Addendum# 1

BID NO.: 101449
OPENING: 2/10/25 at 1:00 PM
COMMODITY: CARLOTTI ROOF REPLACEMENT

1. Provide a copy of the Non-Mandatory Pre-Bid Sign-In Sheet.
2. Answers the questions received by the deadline specified in the above reference bid.

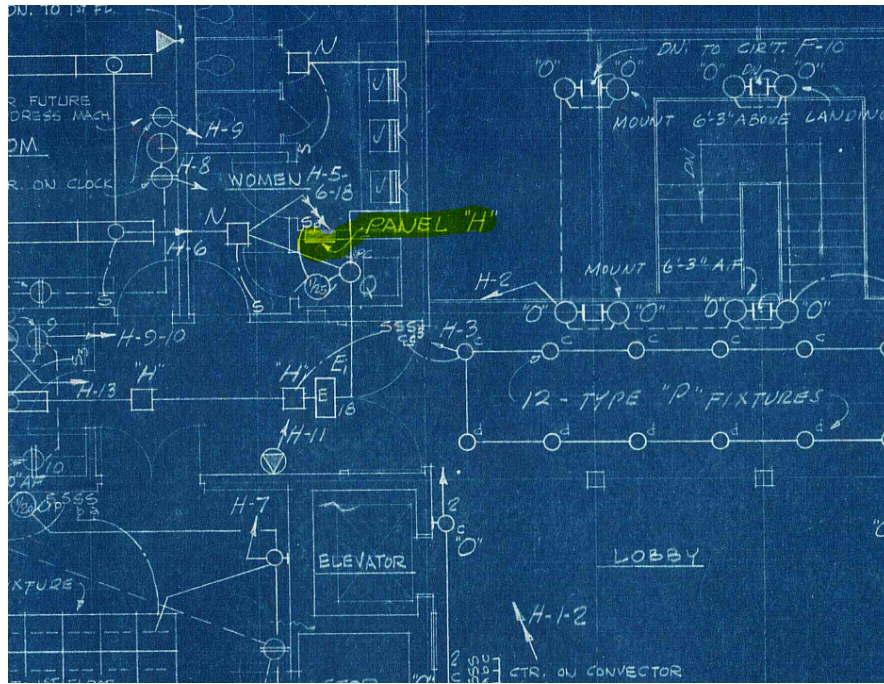
Question 3: Please provide location of electrical panel which the new duplex outlet is to be tied in to.

Answer 3: - Run the new circuit to Panel "H" in the Janitor's Closet off of the Women's Toilet Room 202 (near the elevator on the second floor), as shown on the plan below.
